Connecticut Yankee Atomic Power Company

Notice of Receipt of Plant Procedure License Termination Plan (LTP)

Change No.: 05-01

Haddam Neck Plant License Termination Plan
Distribution of Revision 2A, January 2005
Insert Instruction for Revision 2A of the HNP LTP
Memo RACY-05-017

Figure 5-3

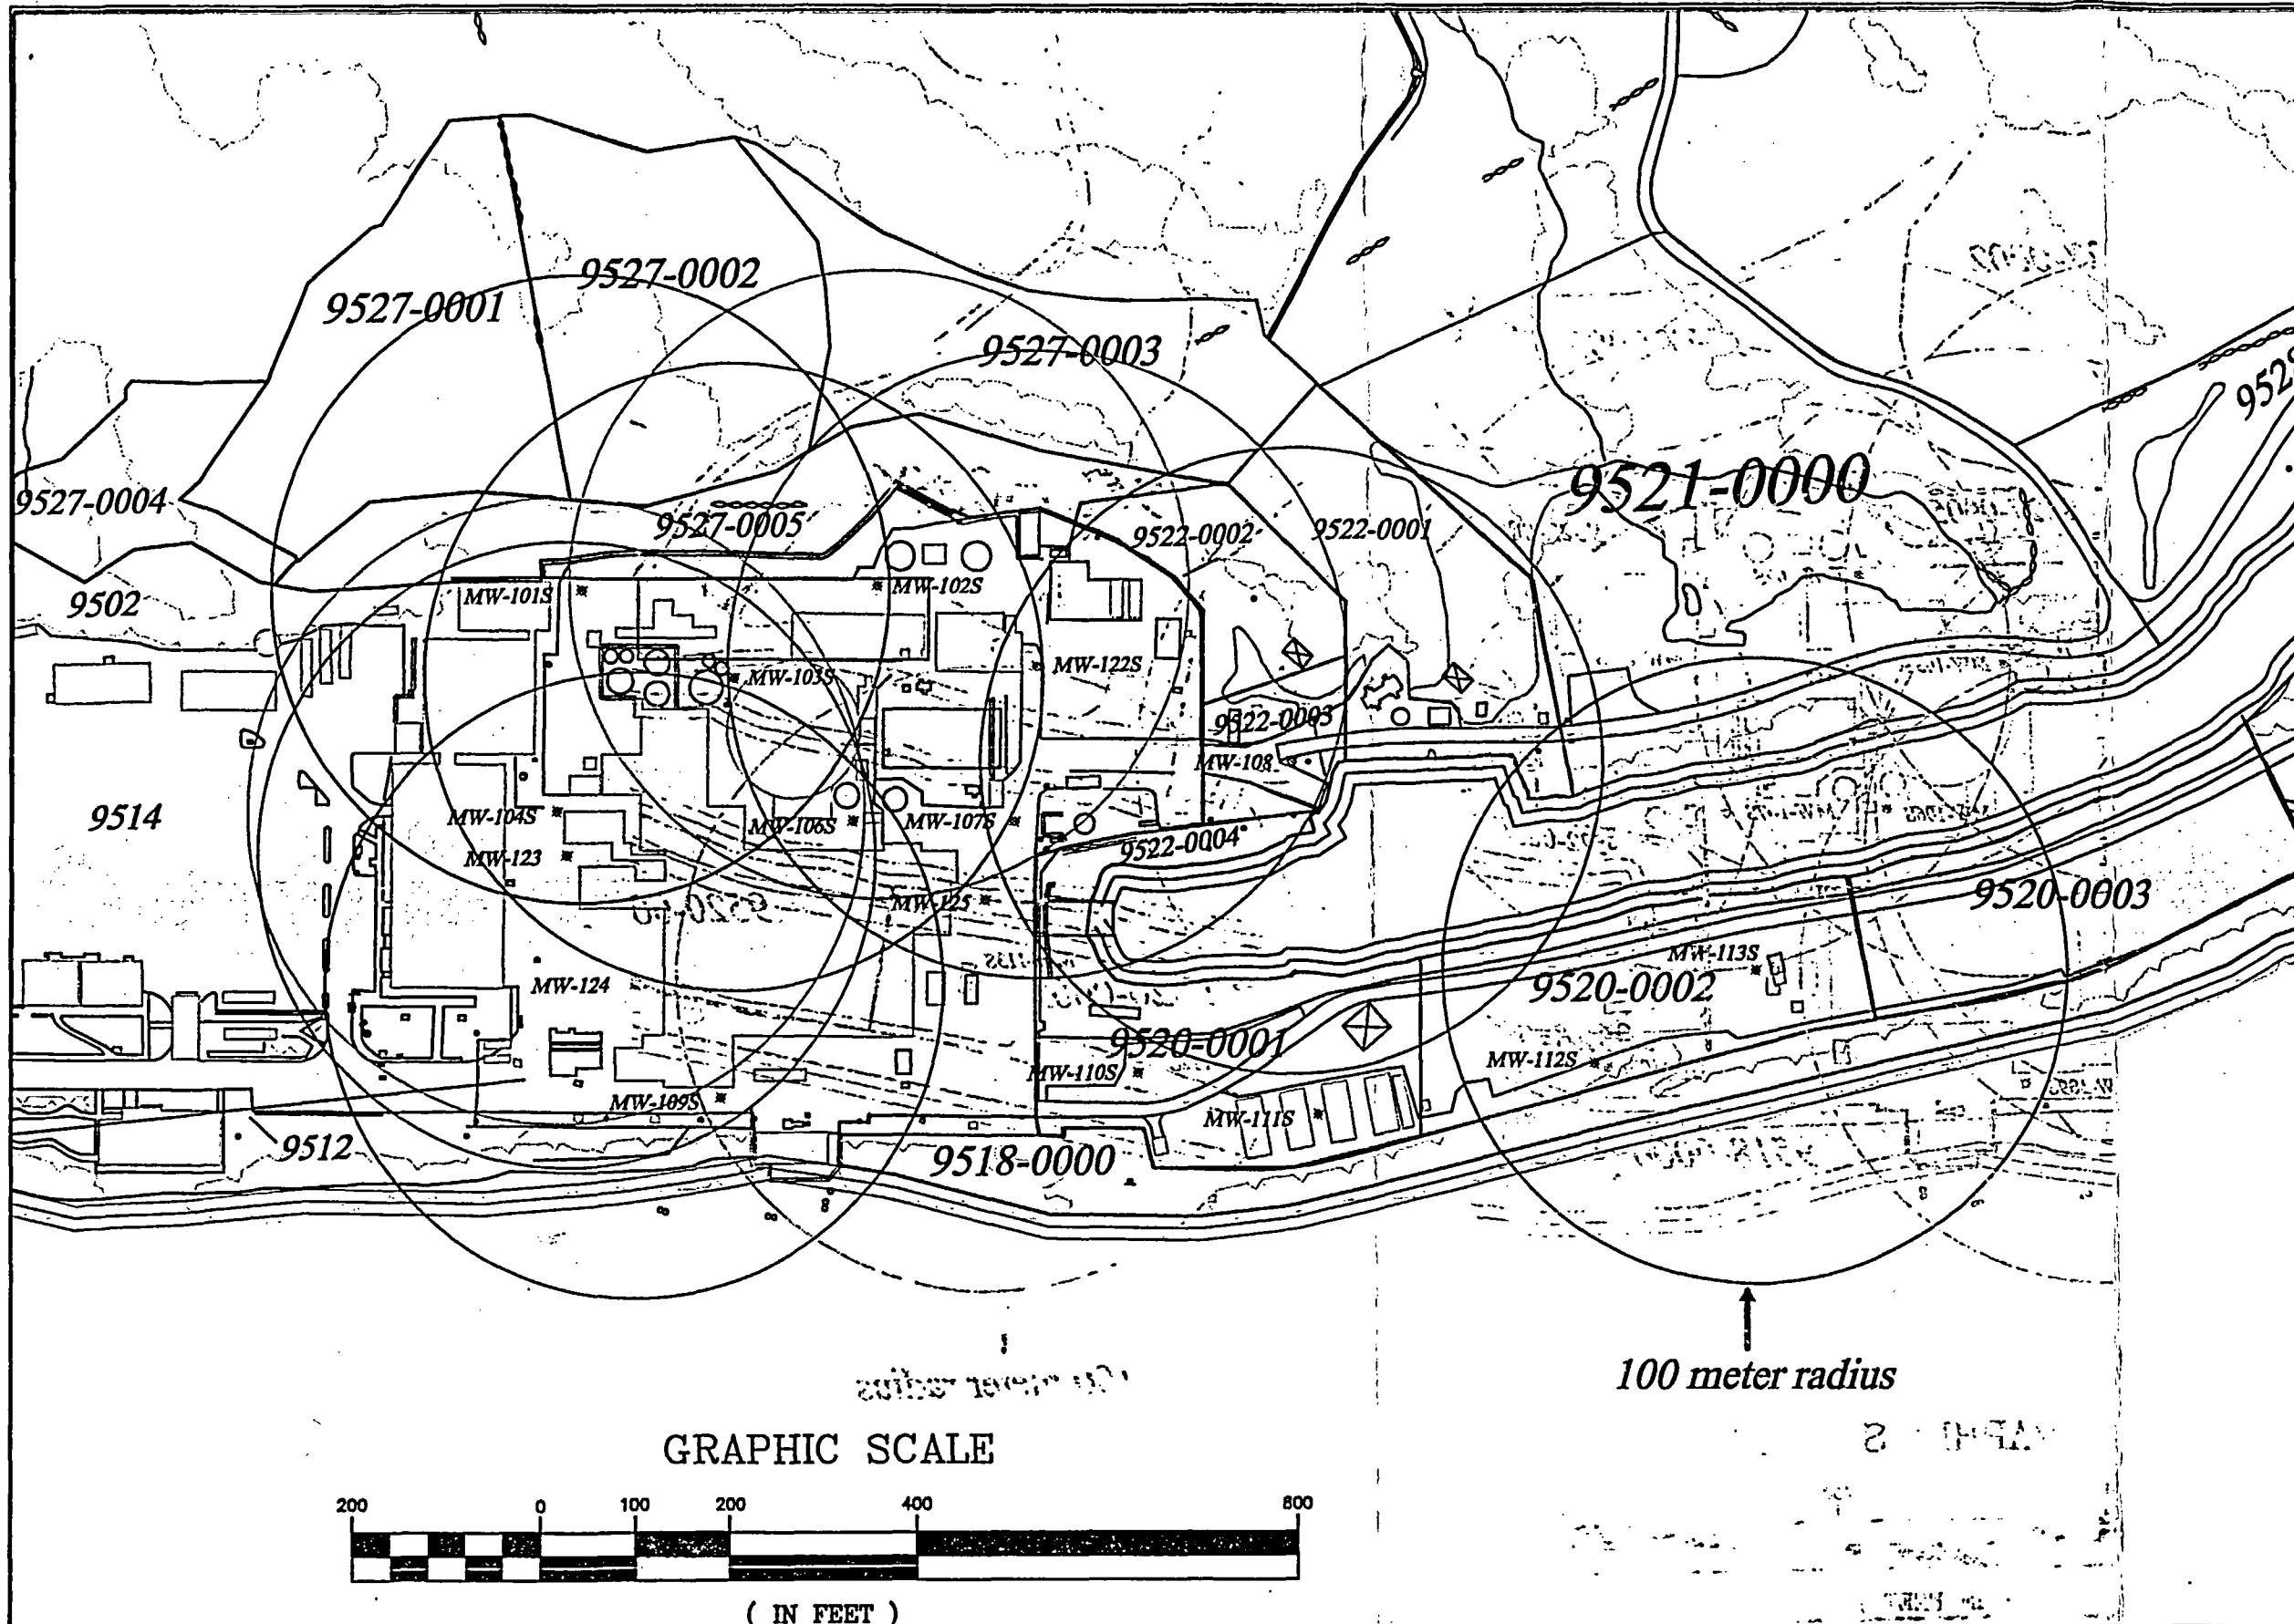
Remove Page(s)	Effective Date	Insert Page(s)	Effective Date
Table of contents Page xi	August 2004	Table of Contents Page xi	January 2005
List of Effective Pages, LEP-1 through LEP-4	August 2004	List of Effective Pages, LEP-1 through LEP-4	January 2005
3-1	August 2004	3-1	January 2005
5-12	August 2004	5-12	January 2005
5-14 through 5-16	August 2004	5-14 through 5-16	January 2005
5-65 and 5-66	August 2004	5-65 and 5-66	January 2005
5-70	August 2004	5-70	January 2005
Figure 5-3 (Old)	Rev 1	New Figure 5-3	Rev 0
None		Insert Figure 5.3-1 after figure 5-3	Rev 0

capture zone analysis determined a maximum zone of influence of 100 meters around a groundwater monitoring well, (see Figure 5-3 and 5-3.1) and reference 5-13, Estimated Zone of Influence/Capture Zone for Hypothetical Water Supply Wells in Post-Closure Dose Modeling, CH2MHILL, Technical Memorandum, dated January 11, 2005. These figures depict the capture zone around the wells which have shown detectable contamination at the perimeter of the industrial area and around peninsula wells.
